JOINT REGIONAL PLANNING PANEL (Sydney East Region)

JRPP No	2014SYE072
DA Number	DA-183/2014
Local Government Area	City of Canterbury
Proposed Development	Demolition of the existing structures and the construction of a mixed use development containing 82 residential apartments, supermarket tenancy, three retail tenancies and basement car parking over three levels for 251 vehicles
Street Address	Nos. 2-26 Haldon Street and 174-176 Lakemba Street, Lakemba (Cnr Lot 1 DP 791007)
Applicant / Owner	DesignInc Sydney Pty Ltd / Tony Jabbour
Number of Submissions	Submissions objecting to the proposal from two neighbouring residents
Recommendation	Approval with Conditions
Report by	Rita Nakhle Senior Planner

Assessment Report and Recommendation

Haldon Street frontage

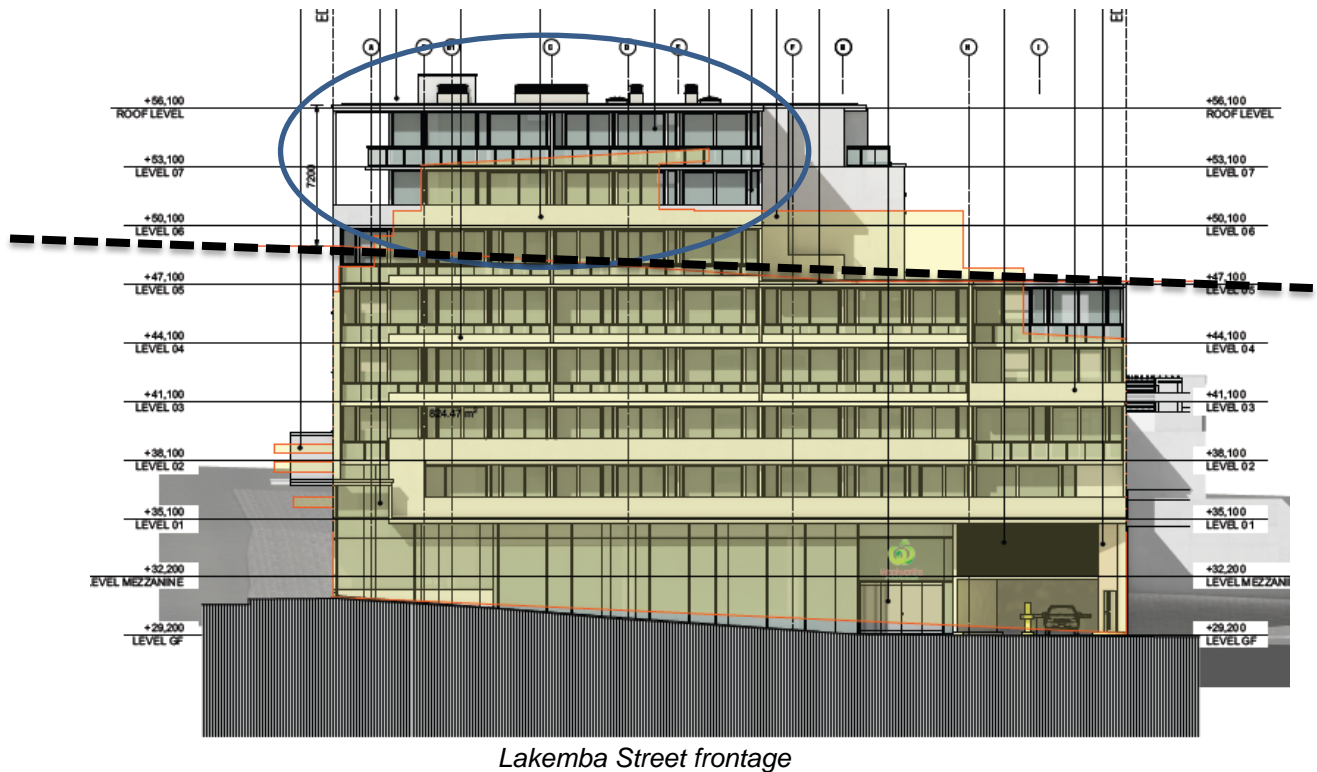
The proposal involves a variation to the maximum height controls for the subject site. The diagram below illustrates that part of the proposed building which exceeds the 18 metre building height limit (18m shown in black dashed line). Also shown in the shadowed forefront, is the building approved under Development Consent 546/2008 (as modified) on the subject site to give a comparison of what is approved and what is proposed on the site. Of most significance, is the added height proposed for the corner component which at its highest point is 25.2 metres in building height.

As such, the applicant has lodged a statement under Clause 4.6 of CLEP 2012.

Having regard to the above commentary, it is considered appropriate in this instance to support the submission under Clause 4.6 of CLEP 2012 and vary the height standards to permit the proposed development.
